Re: Docket No. 04-SPPE-01

**RIVERSIDE ENERGY RESOURCE CENTER
SMALL POWER PLANT EXEMPTION
SUPPLEMENTAL DATA RESPONSE
04-SPPE-01**

Technical Area: Visual Resources

Figure 1 Plume Height and Radial Growth Versus Time, GE LM6000 Combustion Turbine

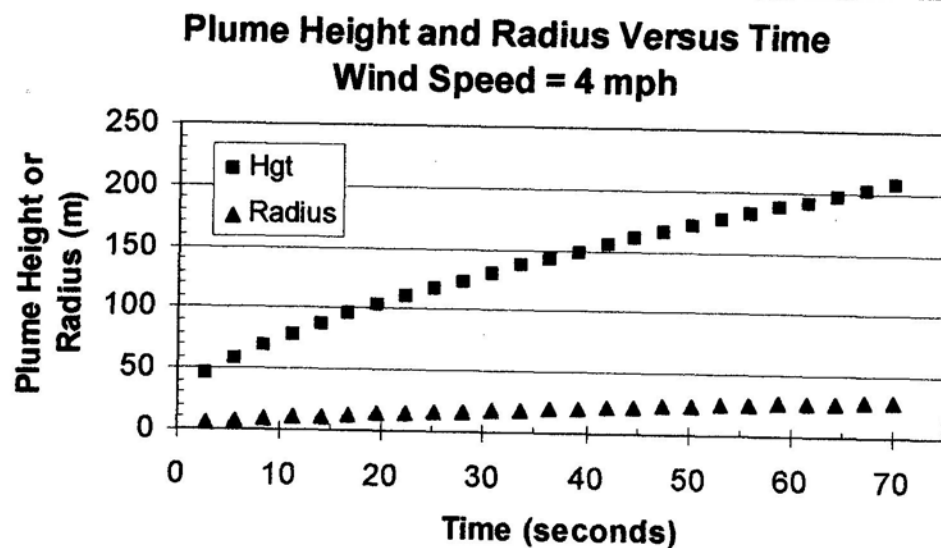
Request: Please provide a description of the thermal plumes resulting from project operation. (DR#61)

61. Provide a detailed discussion of the height, length, width and seasonal occurrence of any visible or thermal plumes that may be generated by the proposed facility into the airspace.

Under a typical wind speed of 4 mph (1.8 meters/second) for the Riverside area, the final (maximum) plume rise for a single plume is approximately 950 meters (including the height of the stack). Under calm wind speed conditions, the plume will transition from momentum-domination to buoyancy-domination at a height above the ground of approximately 67 meters. This transition height will be lower for the typical wind speed of 4 mph for the Riverside area under unstable daytime conditions. Table 2 presents estimated plume height and growth as a function of downwind distance for the momentum-dominated phase of plume rise. Figure 1 presents a plot of plume height and plume radius as a function of time since release out to 70 seconds.
